KANSAS CITY AREA TRANSPORTATION AUTHORITY

REQUEST FOR PROPOSALS (RFP) #F19-5001-53

PURCHASE OF 30-FOOT, 35-FOOT AND 40-FOOT TRANSIT BUSES

ADDENDUM #2

**Addendum #2**  
**ATTACHMENT Q KCATA**  
**RFP #F19-5001-53**

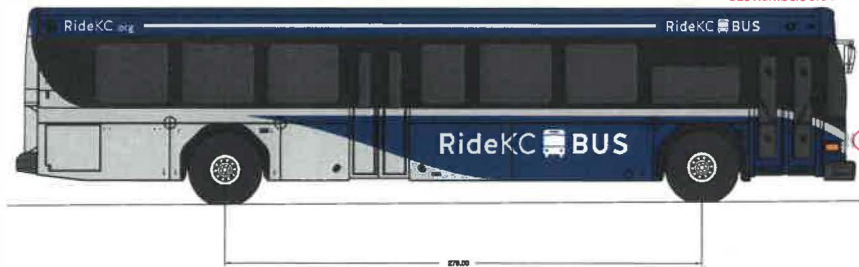
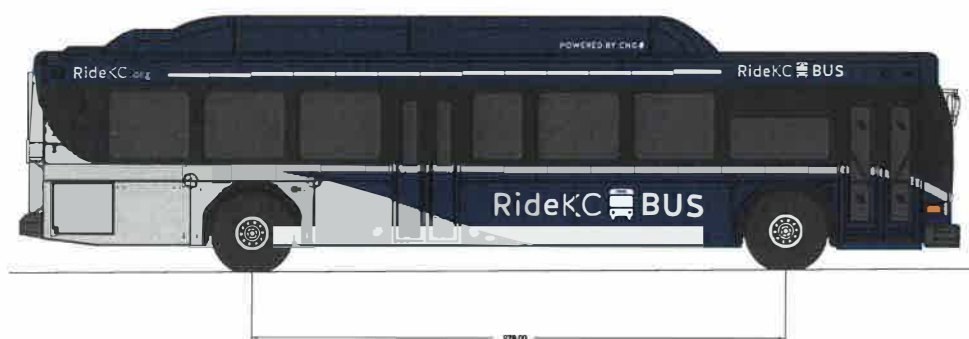
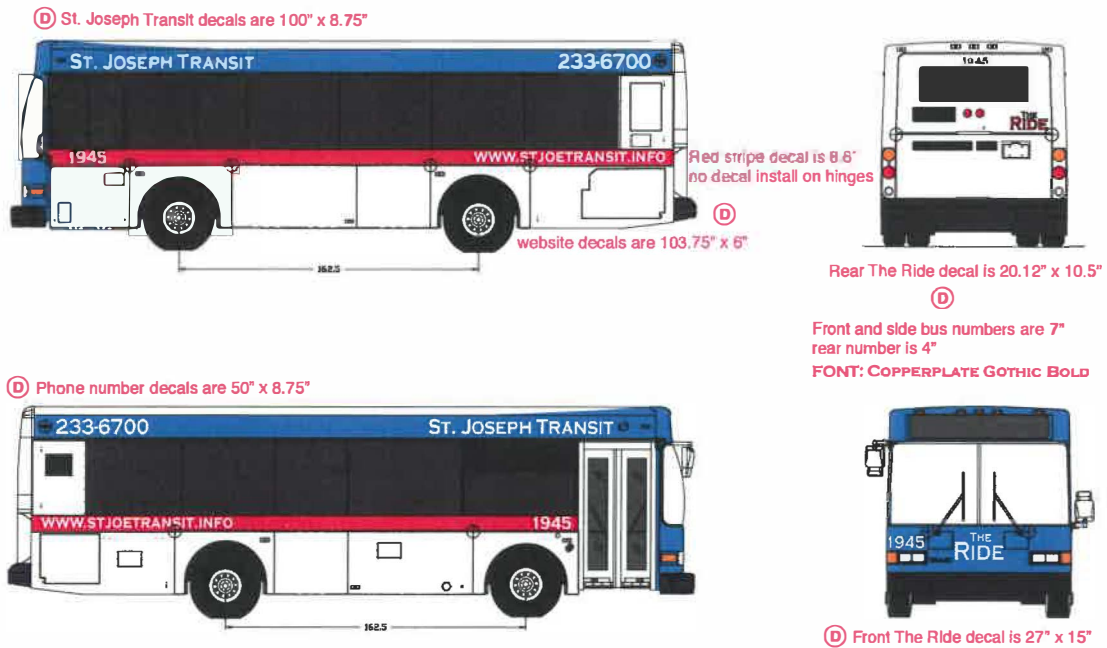
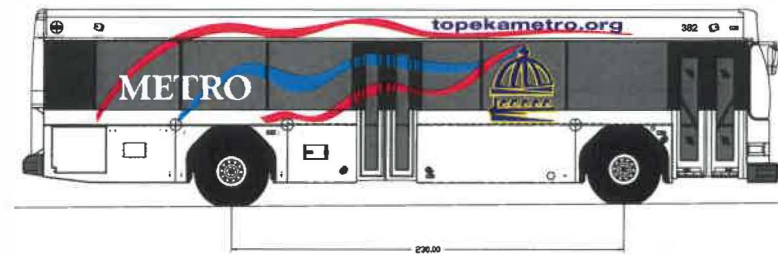
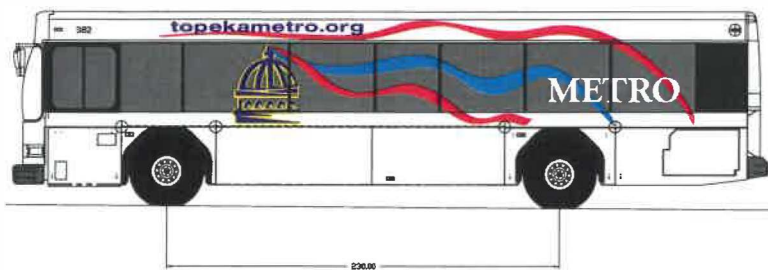
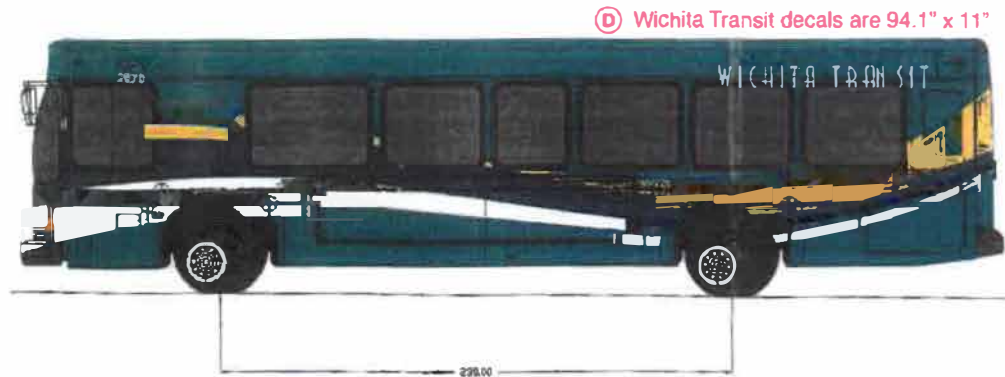
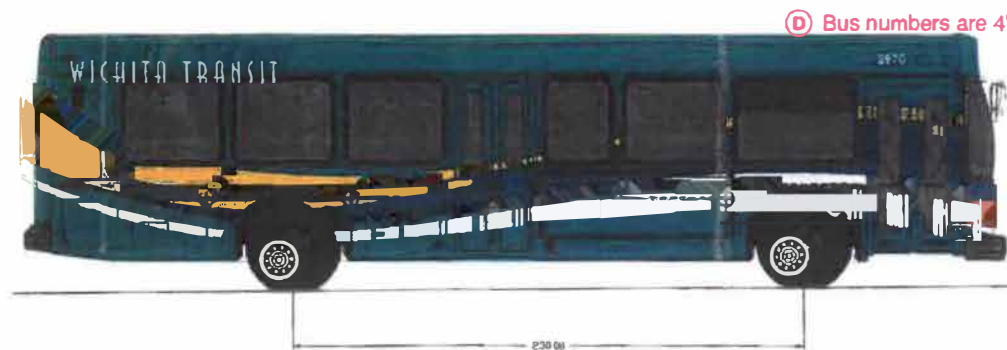
8. **Question:** In section TS72.1, paint colors are not listed. If possible, knowing the colors would be appreciated. Also, if possible, the paint scheme would be nice to have in order to adequately evaluate the work.

**Reply:** See KCATA and Joint Procurement Agencies general design schematic and color examples attached as Attachment Q. Paint scheme will be done during pre-Build.

**KIT & DIAGRAM, SEAT LF2010 40' X 102'**

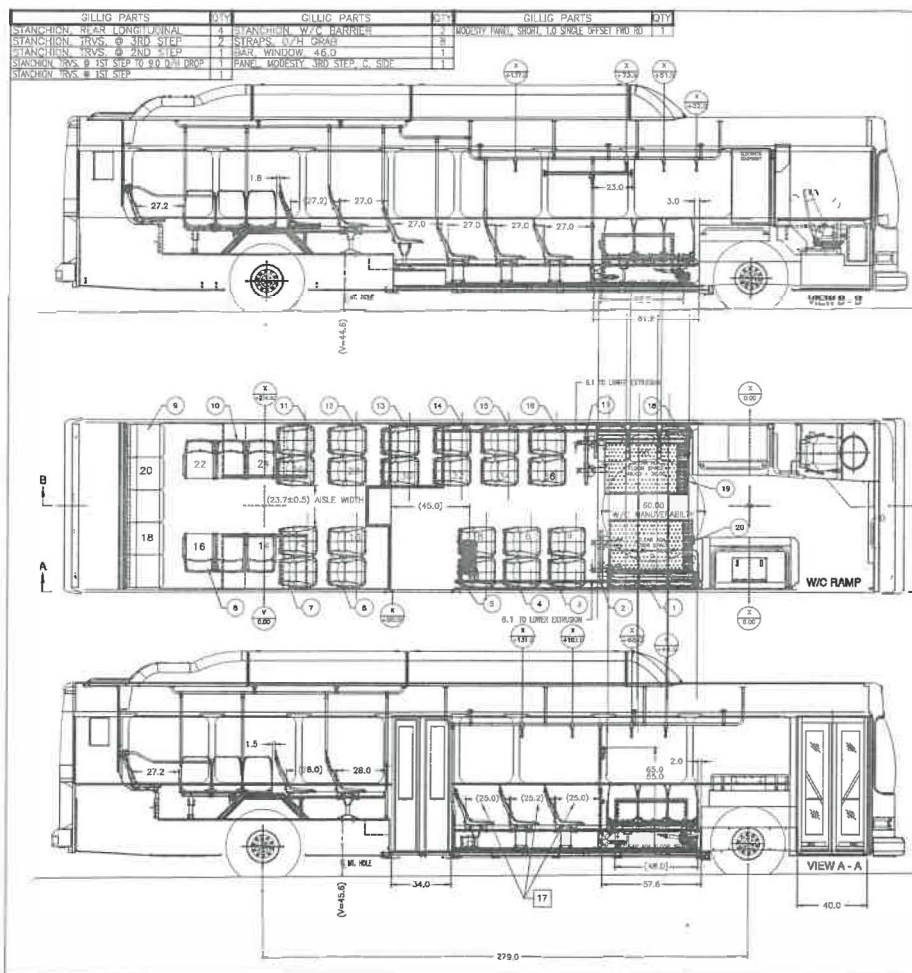
9. **Question:** Since part of the evaluation is based on the seating capacity, we are kindly requesting the current seat layout for guidelines.

12. **Question:** The RFP states the following: "Passenger/Operator Amenities. Purchasing a bus, which meets passenger and operator needs is critical. In the evaluation process the bus will be examined to assure that seating capacity is maximized, and the number of forward-facing seats is maximized. Further, aisle clearance, passenger visibility, and ramping will be considered. The operator's area will be reviewed for comfort and ease of bus operation, layout, driver safety in case of an accident etc. This list is not to be considered comprehensive but only to offer a guideline of standards and elements to be examined." Passenger and Operator Amenities may vary based on the vehicle length and fuel type in the vehicle. In addition, many of these amenities discussed are the result of the use third components which may be used by any OEM on any vehicle, such as a particular driver's seat or a particular data terminal mounting. Please also provide clarity on how the number of forward-facing seats and seating capacity will be evaluated, given that this is largely a function of the bus length and a custom seating configuration available to any bus OEM.

**Reply:** KCATA Seat Layout. See attachment R for seat layout.

**Reply:** KCATA Seat Layout. See attachment R for seat layout.
